Certificate of Appropriateness
2129 Kendall Ave

April 5, 2021

Proposed Work

1 FRONT ELEVATION - PROPOSED
1/4" = 1'-0"

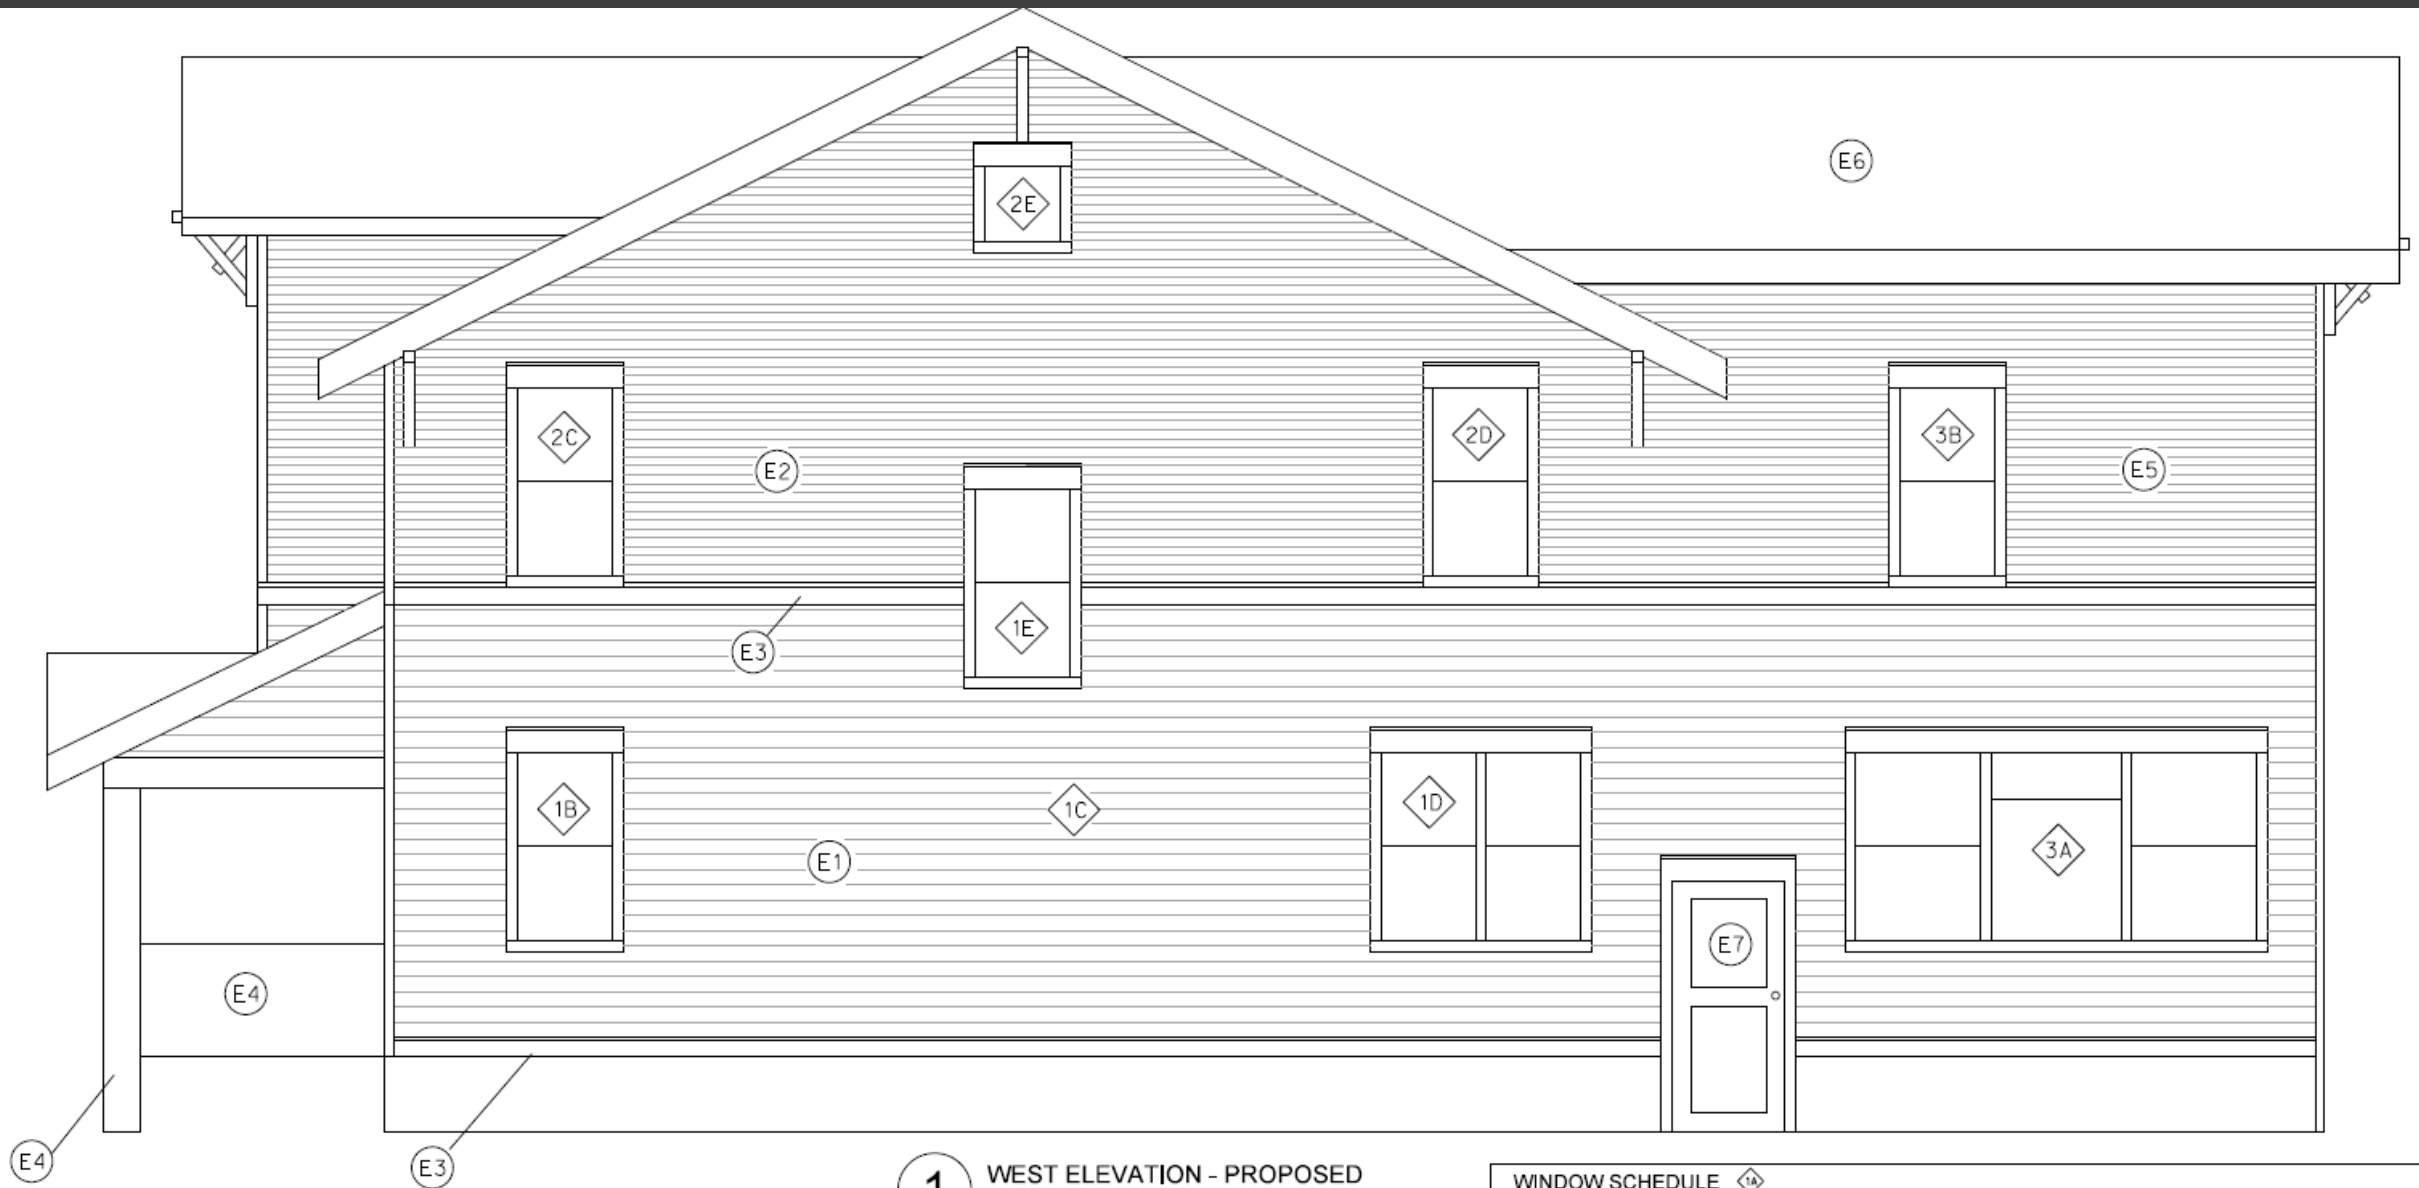
1. Final window specifications shall replicate the appearance of the historic windows
2. Explore repair of the historic front door with a new full-light storm door
3. New roofing shall not have exaggerated shadow lines, with final specifications to be approved by staff
